DYKES ROAD FARMETTES SUBDIVISION, FIRST ADDITION, RESUBDIVISION OF LOT 25

APPLICATION NUMBER 2 DATE September 7, 2006

REQUEST Subdivision

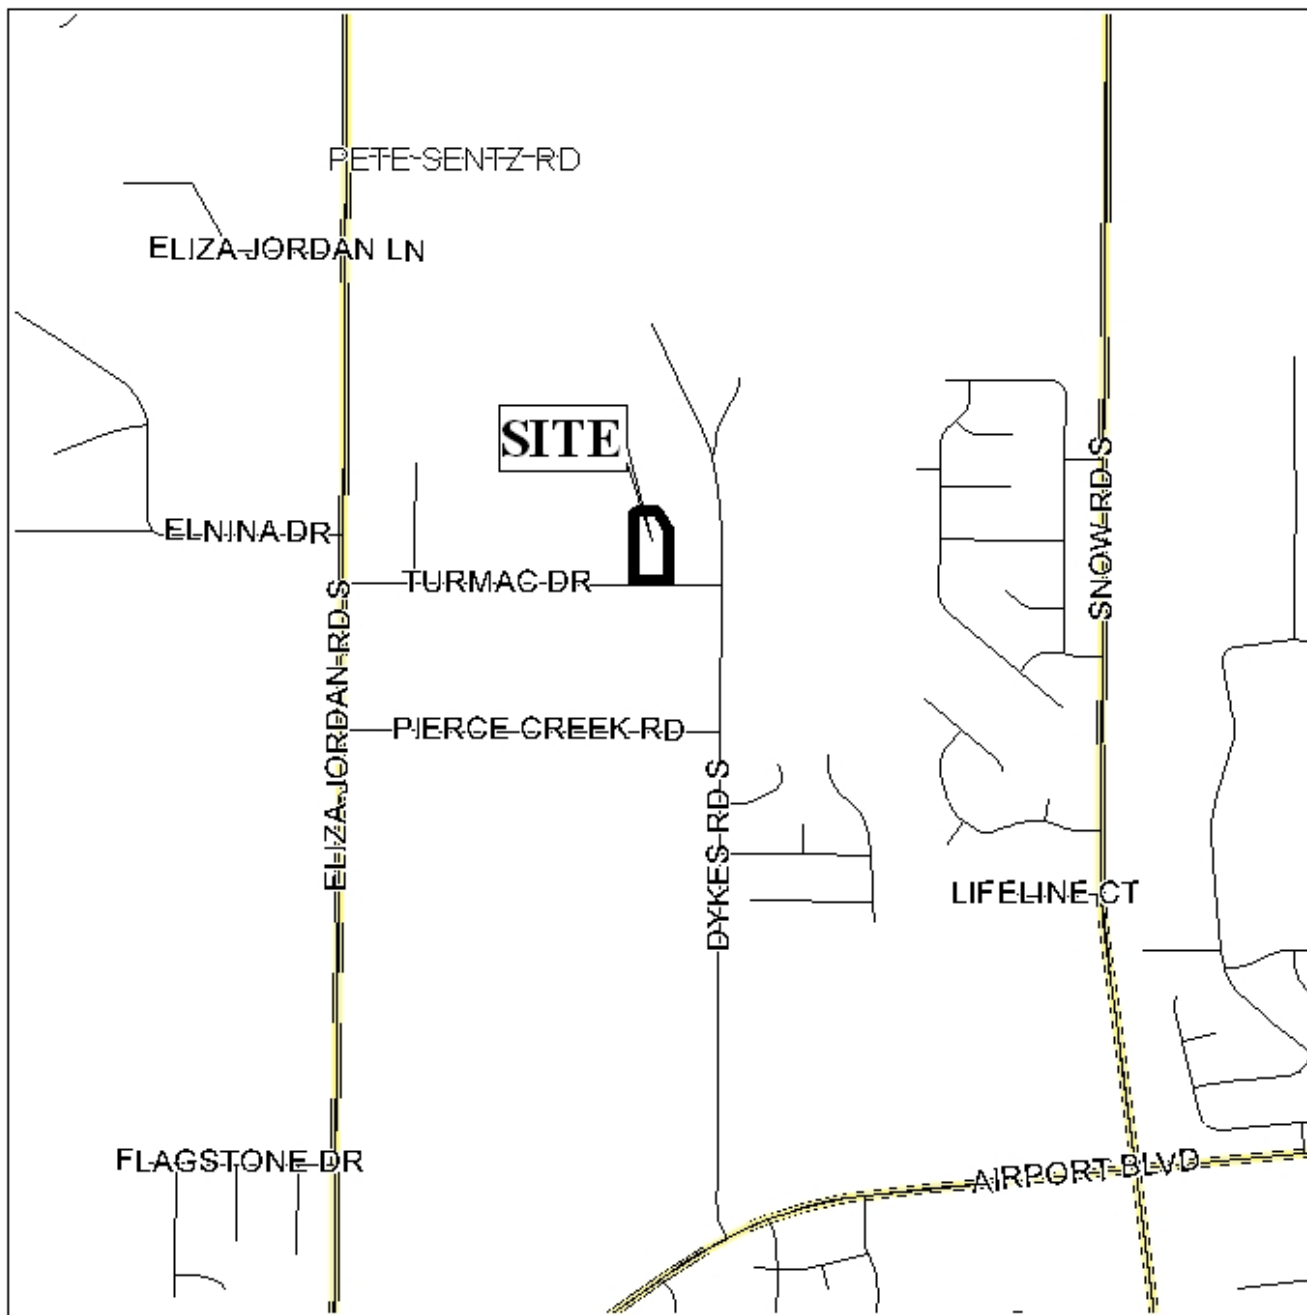
The site fronts Turmac Road, which has a 60-foot right-of-way as shown on the plat.

While the site contains adequate land area for two lots, the proposed arrangement would create a flag-shaped lot. The Subdivision Regulations state that “the size, width, depth, shape, and orientation of lots...shall be appropriate to the location of the subdivision” (Section V.D.1). Flag lots in the area are neither unusual nor the norm. There are two examples of them to the West on Turmac Road, and four on nearby Dykes Road South. Nevertheless, this configuration does present issues of future Resubdivision and the orientation of structures to be built on the rear lot. It also presents challenges to emergency vehicle access. However, given that the site is limited by the existing structure centered on the lot, and that the site otherwise meets the minimum standards of the Regulations, and that this type of development is found nearby, it may be excused in this case.

A 50-foot building setback line is shown on the plat, which would exceed the 25-foot minimum.

This site is located in Mobile County, thus a note should be placed on the Final Plat stating that any lots which are developed commercially and adjoin residentially developed property must provide a buffer, in compliance with Section V.A.7 of the Subdivision Regulations.

Based on the preceding, this application is recommended for Tentative Approval, subject to the following conditions: 1) the placement of a note on the final plat stating that there will be no future Resubdivision of Lot 2 until additional access on a publicly maintained street is available; and 2) the placement of a note on the final plat stating that any lots which are developed commercially and adjoin residentially developed property must provide a buffer, in compliance with Section V.A.7 of the Subdivision Regulations.
